FINAL ENVIRONMENTAL IMPACT REPORT

VOLUME 1 COMMENTS, RESPONSES, AND ERRATA

**DOUGHERTY VALLEY GENERAL PLAN AMENDMENT,
SPECIFIC PLAN, AND RELATED PROJECTS**

November 1992

Figure 6-2. Existing Tri-Valley Volumes

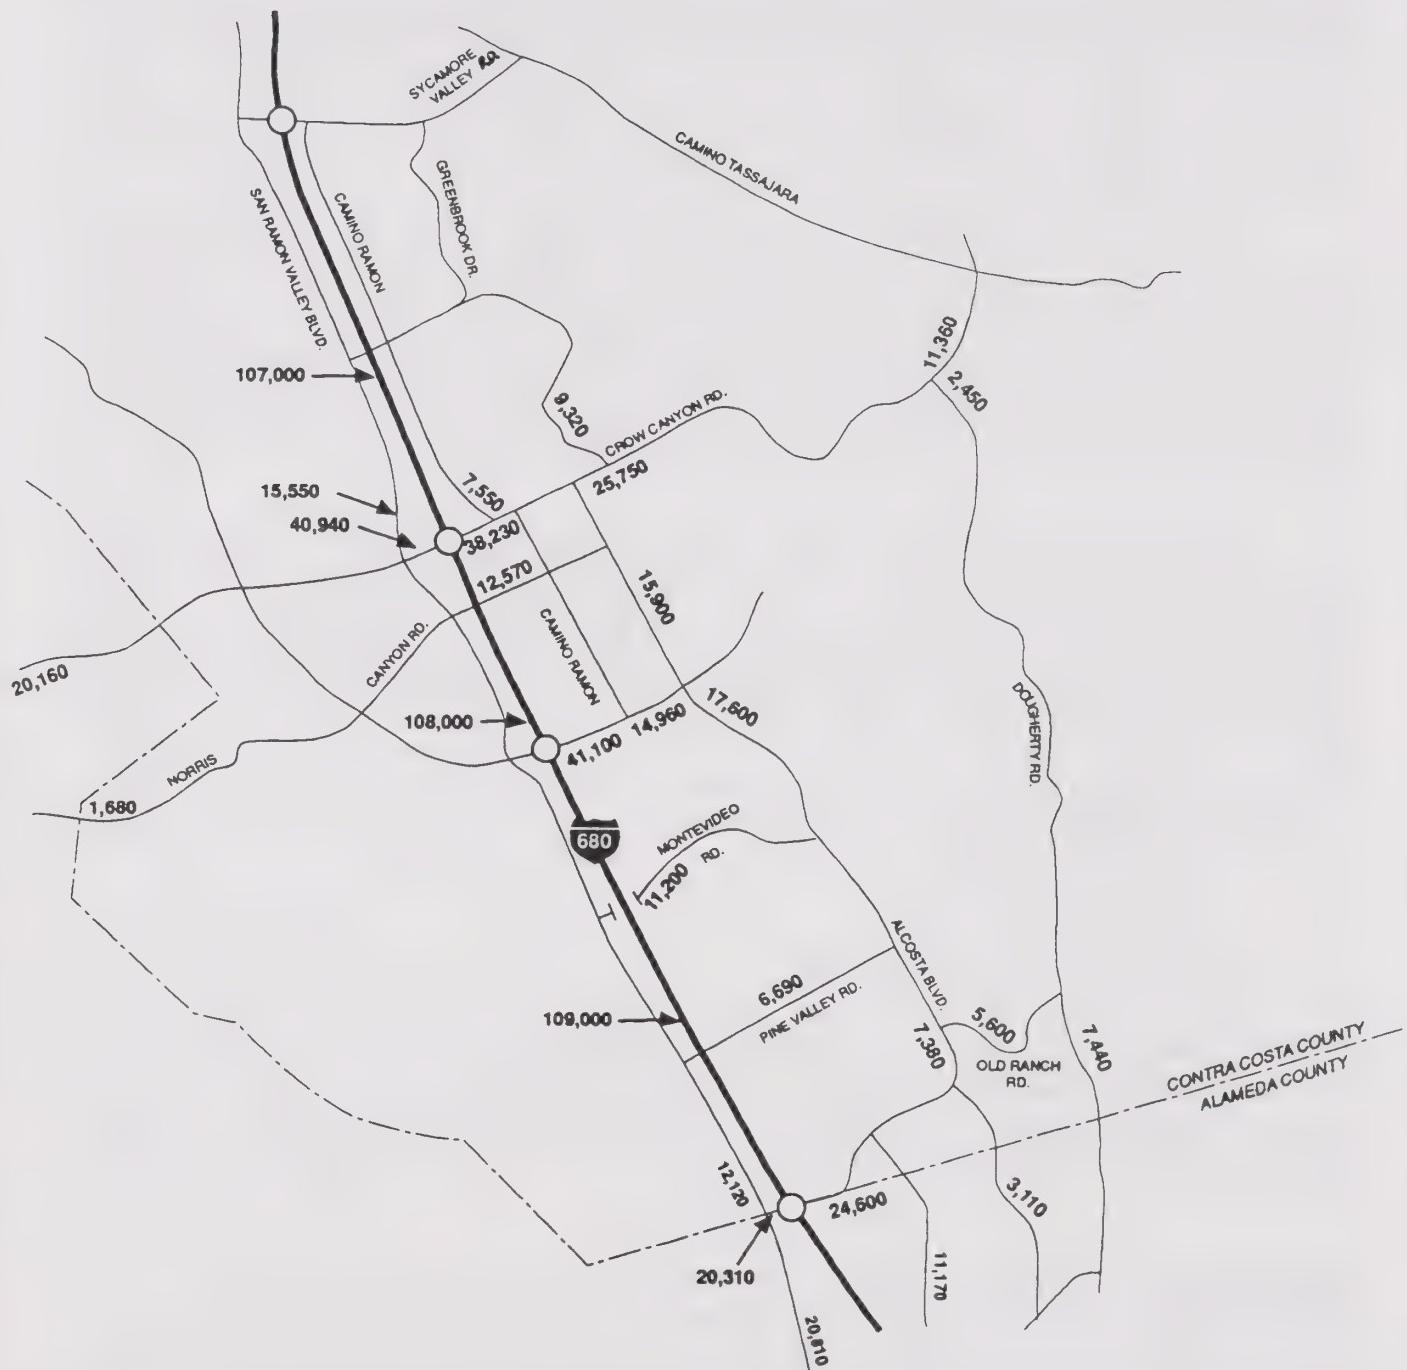
Figure 6-2 should be changed to show 18,000 at this location.

Figure 6-2. The volumes shown are incorrect. Village Parkway should be 16,700, Dougherty Road north of Amador Valley should be 5,300, Dublin Boulevard east of Village Parkway should be 24,000 and Dougherty Road south of Dublin Boulevard should be 44,200. See TJKM volumes of 1991.

- 7-88 Peak-hour traffic counts taken by TJKM on November 14, 1990, were factored to estimate daily volumes assuming 10% of the daily volumes occurred in the peak hours. The resulting daily volume was 12,830 vehicles, which was rounded up to 13,000 as shown in Figure 6-2. A 2-day count during the same week on Camino Tassajara east of Sycamore Valley Road showed an average of 18,000 daily trips as noted in the comment. Comparing the hourly volumes between these two counts, it appears that the peak-hour observations were undercounted. Figure 6-2 and referencing text are revised to indicate 18,000 vpd at this location.

- 8-10 The daily traffic volumes shown in Figure 6-2 in revised Chapter 6 (see Errata), generally represent 1990 traffic conditions. In a few locations, 1991 volumes were used where counts from the previous year were not available. All counts in Dublin reflect 1990 conditions. Figure 6-2 has been revised to include the 5,300 ADT on Dougherty Road north of Amador Valley Boulevard.

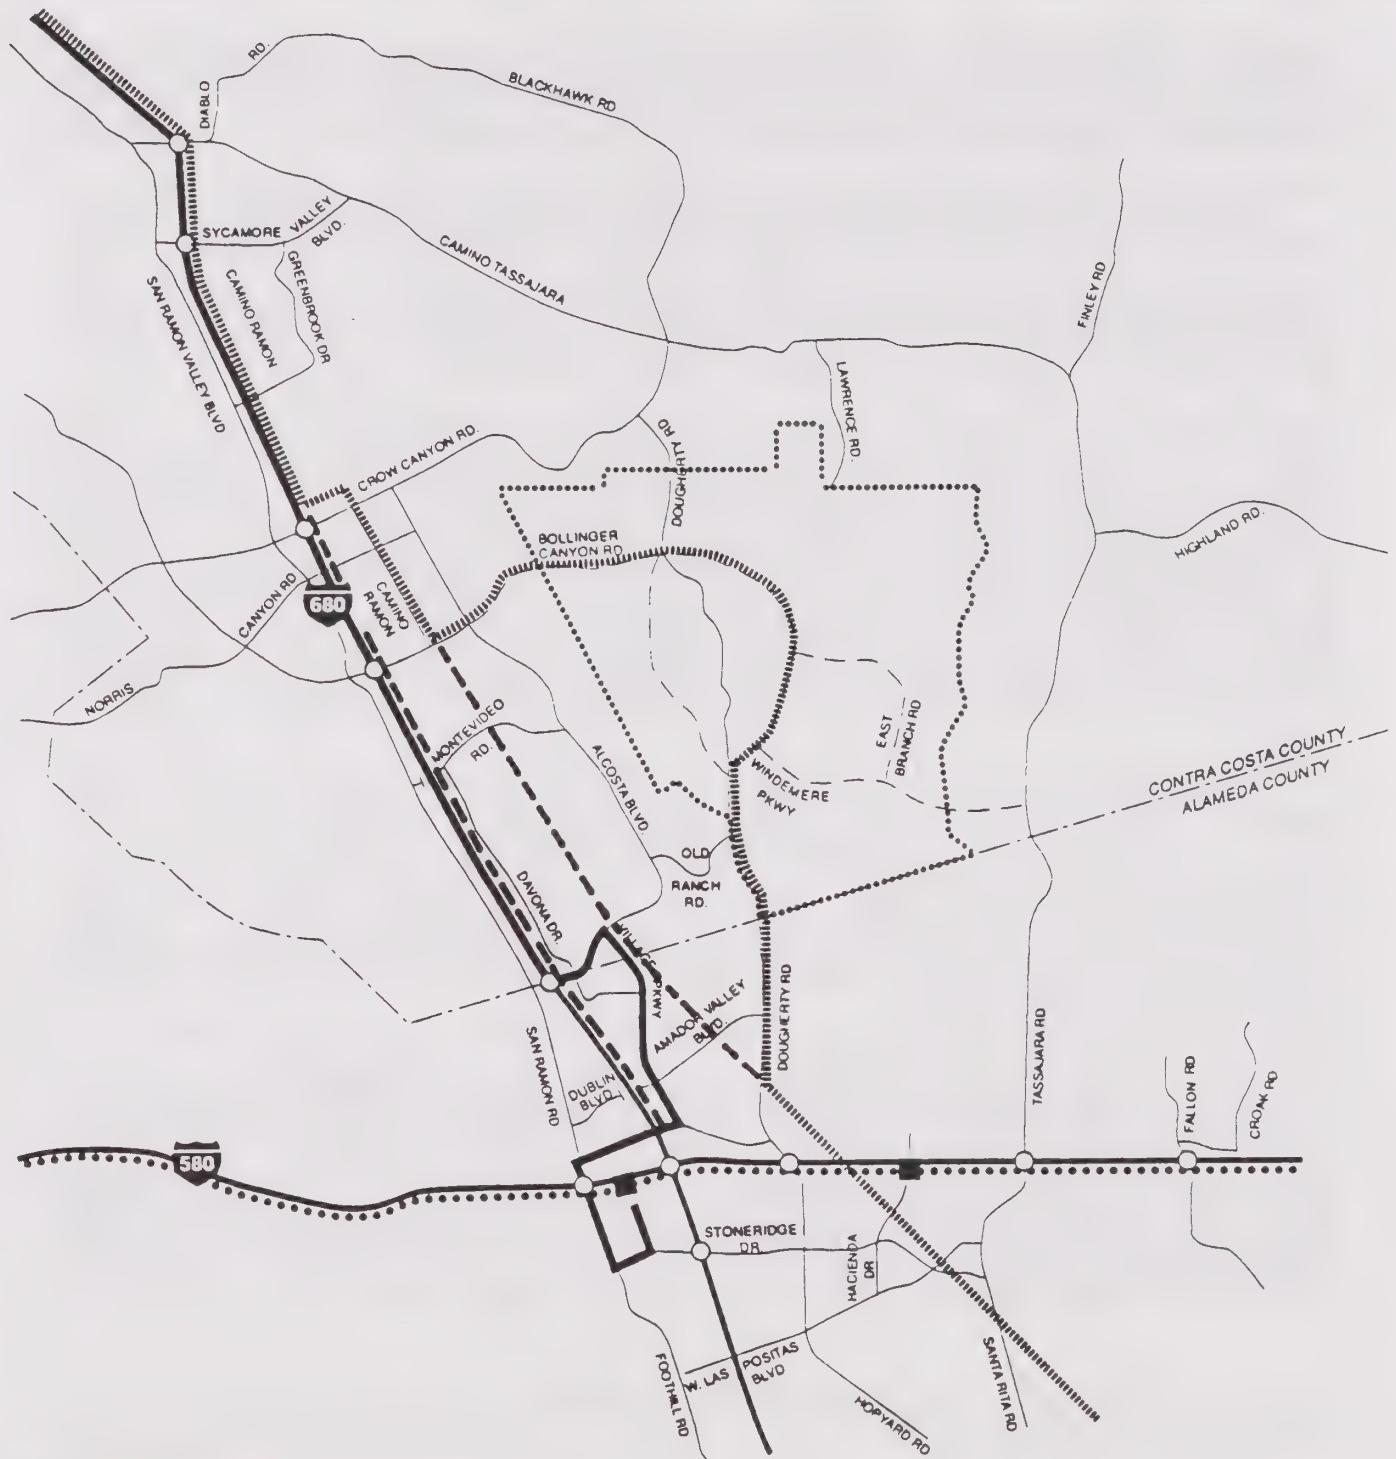
- 2) Correction to Figure 6-5, Planned Roadway Improvements, Page 6-17. Interstate (I)-580/680 Future Improvements will begin in 1996 according to current schedule. 16

| <p>14. Figure 6-5, Planned Roadway Improvements</p> <p>The Twin Creeks Drive Extension project should be deleted as it is no longer a part of City CIP program.</p> | <p>14</p> |

Figure 6-5. The title should read "Planned Roadway Improvements by 2010". The I-580/I-680 future improvements are not completely funded and may not begin in 1994.

- 5-51 Comment noted. Figure 6-5 in the Draft EIR has been revised to correctly name Deerwood Road and to delete the previously shown Twin Creeks Drive extension. The Twin Creeks Drive extension was erroneously shown in Figure 6-5 but was not included in the traffic model network assumptions (refer to Appendix D for the complete listing of planned roadway improvements). Therefore, the deletion of the Twin Creeks Drive extension from the planned roadway improvements does not change any traffic forecasts.

- 7-92 Figure 6-5 has been revised to show Camino Tassajara between Sycamore Valley Road and Diablo Road as two lanes existing and planned. This correction does not substantially alter the traffic analysis in the Draft EIR.

Figure 6-7. Average Daily Traffic

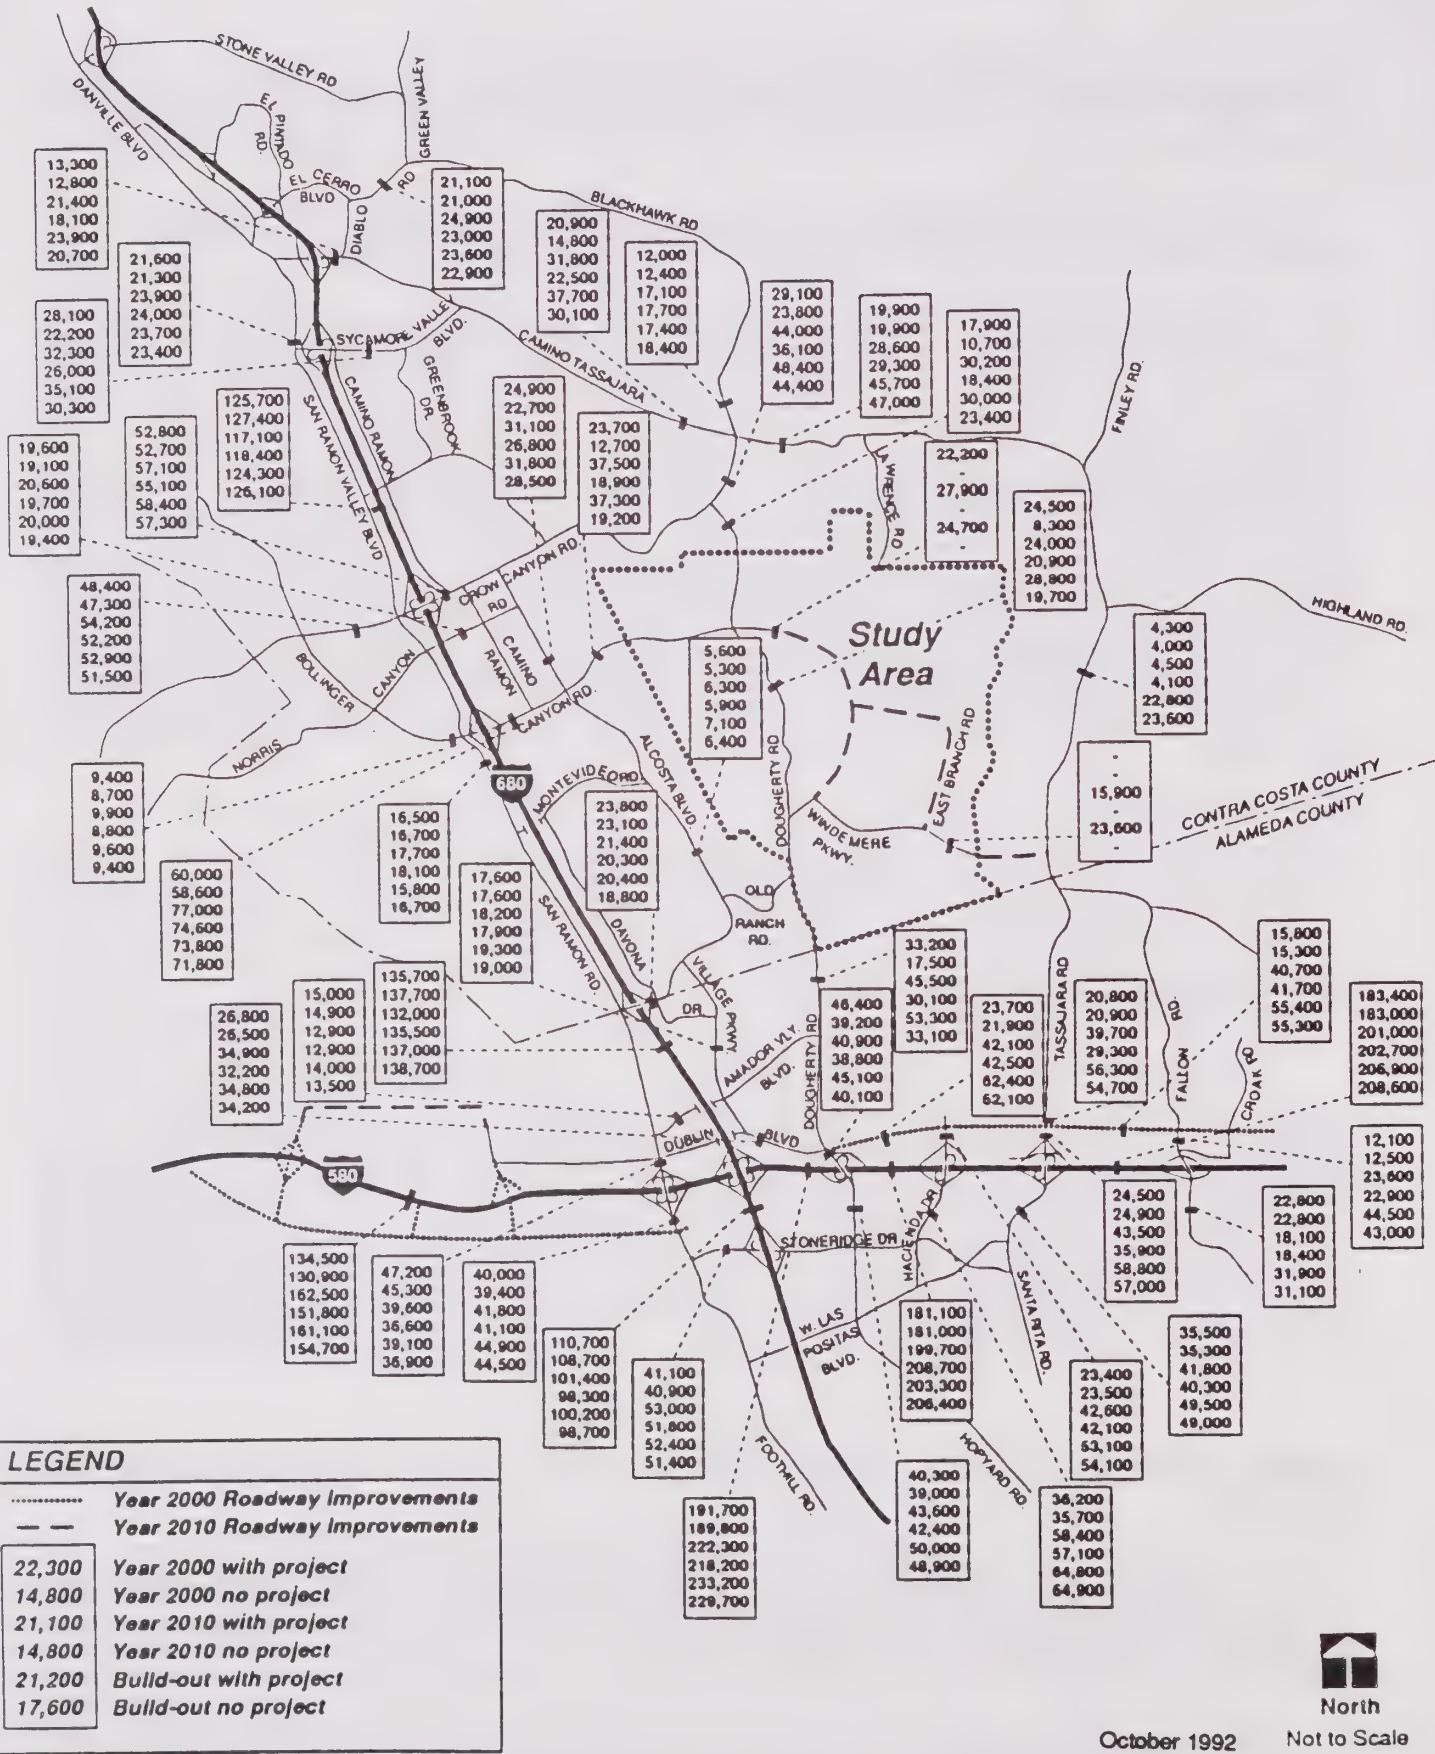
- 5) Last paragraph on Page 6-28. Southern Pacific Right-of-Way is not shown on Figure 6-6, Planned Transit Improvements. 19
- 6) Correction to Figure 6-7, Average Daily Traffic (ADT), on Page 6-32. The segment on Tassajara Road that requires mitigation measure implementation is between Dublin Boulevard and Fallon Road according to the text. The figure shows that segment being on the south side of Dublin Boulevard. 20

Figure 6-7. An analysis of the ADT's shown in this Figure indicates a total "External Project Traffic" in 2010 of 72,000 and 70,900 at buildout. Why does the external traffic decline at buildout? If 30% the total ADT of 168,810 shown in Table 6-4 is subtracted from the total ADT, 118,167 ADT will impact areas outside of the project. These two numbers differ drastically. It would seem that the ADT's given in the figure are very low. Please address this in the EIR.

Figure 6-7: This figure shows a total "External Project Traffic" at buildout of 70,900 (derived by subtracting "no project" from "project"). Yet Table 6-4 indicates that the project should have an external generation of 118,167 ADT. How are the missing trips accounted for?

- (11) Figure 6-7 of the DEIR shows approximately 72,000 total daily trips entering and leaving the Dougherty Valley planning area ("external" trips), in the year 2010. This appears inconsistent with estimated project trip generation, and the assumption that 30 percent of project trips occur within the Dougherty Valley (168,000 total project trips minus 51,000 "internal" trips equals 117,000 "external" trips). Similar problems are noted for the buildup scenario. | 11

- 6-26 Comment noted. This information is now included in the record.
- 6-27 The revised traffic forecasts show a 10,400 daily vehicle difference on Tassajara Road north of Dublin Boulevard in 2010 with the project. Refer to Figure 6-7 of revised Chapter 6 in the Errata (Attachment 2) in the Final EIR. See Errata.

Figure 6-7 has been revised based on the new traffic forecasts; however, the essence of the comment applies equally to both the old and new forecasts. In several locations in the study area, daily volumes were found to decrease between 2010 and buildout. The reason for the decrease ties directly to the assumed growth in Tri-Valley employment. Between 2010 and buildout, approximately 100,000 additional employees are forecasted for the Tri-Valley area. According to ABAG, the increase in housing during that period is only 20,000, or roughly 32,800 employed residents (1.64 per household). As a result, the ratio of jobs to housing will shift dramatically from its current, or even the 2010, situation. The 1990 jobs/housing ratio of 1.41 jobs per household is projected to be 1.45 in 2010, but it will increase to 1.85 if all of the employment capacity identified in the buildout scenario is realized.

- 8-23 The daily volume projections for Fallon Road have been included in Figure 6-7 of revised Chapter 6 (see Errata).
- 8-24 The revised traffic projections show ADT volumes on Windemere Parkway with the Dougherty Valley project as 15,900 in 2010 and 25,900 at buildout. Tassajara Road north of I-580 shows differences with and without the project in 2010 as 7,600 and at buildout as 13,100. In both cases, about half of the project ADT on this route is absorbed in East Dublin. This is reasonable because it also represents about half of the total trips to and from greater Dublin. According to the 2010 project trip distribution, 12% of the total daily trips, or 14,000 ADT, will be made to and from Dublin and East Dublin. The noted difference of 7,600 ADT is about half of the total 14,000 ADT to Dublin. Refer to revised Chapter 6 (see Errata).

Figure 5-1. Wastewater Service Districts in the Dougherty Valley Planning Area and Vicinity

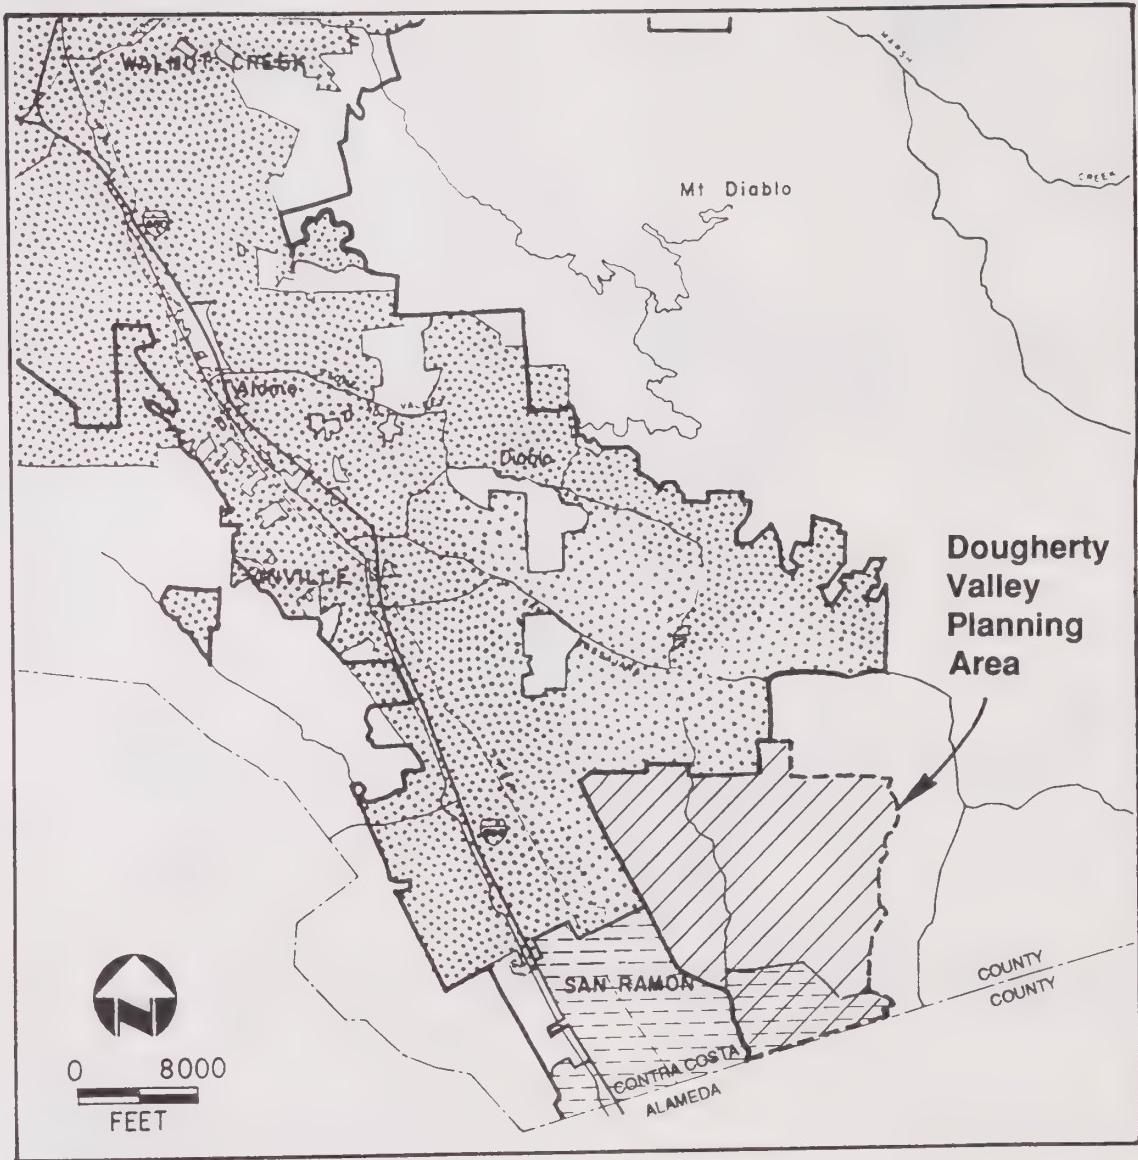
15. Figure 5-1 - The service area and sphere of influence boundaries of DSRSD and Central Contra Costa Sanitary District cannot be determined from this figure. The DSRSD District boundary as indicated by the stipple shading is correct and exactly matches the District's sphere of influence boundary in Contra Costa County. The sphere of influence boundaries shown are inaccurate and misleading for both DSRSD and CCCSD.
